Access Compliance Report Public Rights-of-Way (Curb Ramps)

Main Street: COPIOUS_LN		Cross Street: EPONA_WAY		Location:	S
ADA ID: RPRK211027142439	Ramp Type: Type 4 - Parallel	Initial Pass/Fail: Pass	Overall Compliance: No	Severity Score:	25

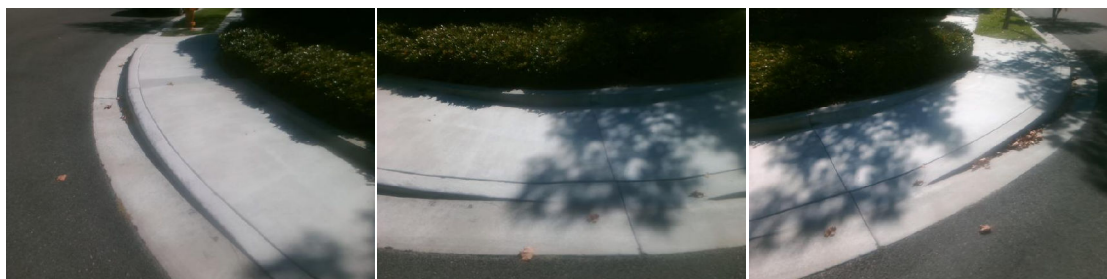
Remove & Replace Curb Ramp With Two New Directional Ramps or Equivalent. Remove & Replace Gutter.

Compliance	Description	Data	Compliance	Description	Data
N/A	Ramp Length LT (in)	134	N/A	Ramp Length RT (in)	140
Yes	Ramp Width LT (in)	53	Yes	Ramp Width RT (in)	53
Yes	Ramp Run Slope LT (%)	4.9	Yes	Ramp Run Slope RT (%)	4
Yes	Ramp Cross Slope LT (%)	1.4	Yes	Ramp Cross Slope RT (%)	0.8
N/A	Landing Present	No	No	DWS Provided	No
N/A	Landing Length (in)	N/A	N/A	DWS Contrast	N/A
No	Landing Width (in)	N/A	N/A	DWS Length (in)	N/A
No	Landing Run Slope (%)	N/A	N/A	DWS Full Width	N/A
No	Landing Cross Slope (%)	N/A		DWS Offset Type	N/A
N/A	Landing Movement Obstructed?	No	N/A	DWS Offset Left (in)	N/A
	Landing Movement Type	Curb	N/A	DWS Offset Right (in)	N/A
N/A	Landing Shared	N/A			
N/A	Clear Space	Yes			
N/A	Clear Space To Crosswalk (in)	48			
N/A	Marked Crosswalk 1	No	N/A	Marked Crosswalk 2	No
	Crossing 1 Direction	NE		Crossing 2 Direction	NW
N/A	Marked Crosswalk 1 Width (in)	N/A		Marked Crosswalk 2 Width (in)	N/A
N/A	Ramp Inside Crosswalk 1	N/A	N/A	Ramp Inside Crosswalk 2	N/A

Crossing 1 Slope (%)	3.8		Crossing 2 Slope (%)	2.7
	Crossing 1 Cross Slope (%)	0.1		Crossing 2 Cross Slope (%)	3.5
Yes	Gutter Ponding	No	Yes	Curb Slope	4.4
Yes	Gutter Lip Height (in)	0		Road Run Slope (%)	0.2
No	Gutter Run Slope (%)	6.3		Road Cross Slope (%)	5.2
Yes	Gutter Cross Slope (%)	1.9	No	Perpendicular Joint Present	No
Yes	Overall Surface Condition	Acceptable			
	Cross Gutter Present?	No		Spandrel Present?	No
	Replace Cross Gutter?	N/A		Replace Spandrel?	N/A
